[Issue No.] GOT-A-0127

[Title] Change in Appearance of External Connection Cables for GOT2000 Series and GOT1000 Series Handy GOT

[Date of Issue] March 2018

[Relevant Models] External Connection Cables for GOT2000 Series, GOT1000 Series Handy GOT

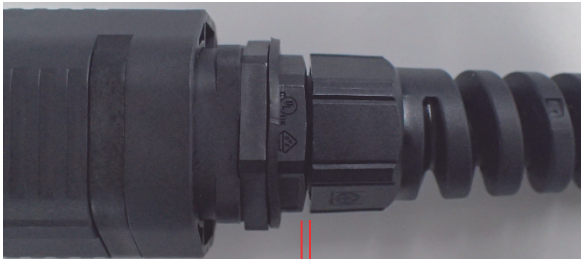
The appearance has been changed to prevent the clamp inserted into the connector of the external connection cable for Handy GOT from being loose.

From this change, the clearance between the connector and the clamp becomes large.

The following shows the difference in clearance between the connector and the clamp, which is generated due to the appearance change.

Before	After
 <p data-bbox="478 1680 654 1747">Approx. 0.5 mm (reference value)</p>	 <p data-bbox="1165 1680 1340 1747">Approx. 1.5 mm (reference value)</p>

**2.1 GT1□H-C□□-42P cable**

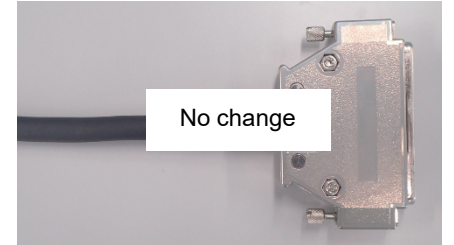
Model name	Handy GOT side connector	GT16H-CNB-42S side connector
GT16H-C30-42P GT16H-C60-42P GT16H-C100-42P		
GT14H-C30-42P GT14H-C60-42P GT14H-C100-42P

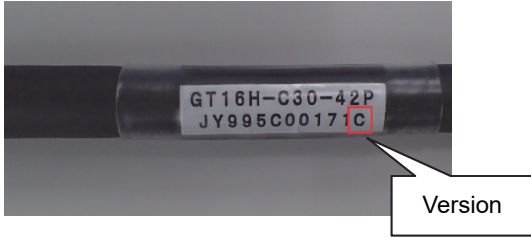
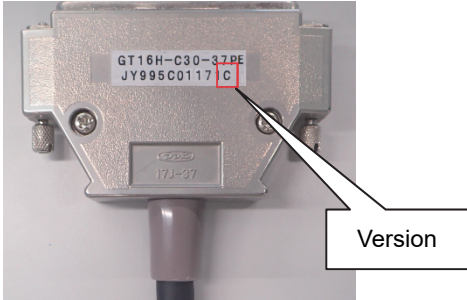
**2.2 GT16H-C□□-32P cable**

Model name	Handy GOT side connector	GT11H-CCL, GT11HS-CCL side connector
GT16H-C30-32P GT16H-C50-32P GT16H-C80-32P GT16H-C130-32P

**2.3 GT16H-C□□-37PE cable**

Model name	Handy GOT side connector	GT16H-CNB-37S side connector
GT16H-C30-37PE GT16H-C60-37PE GT16H-C100-37PE
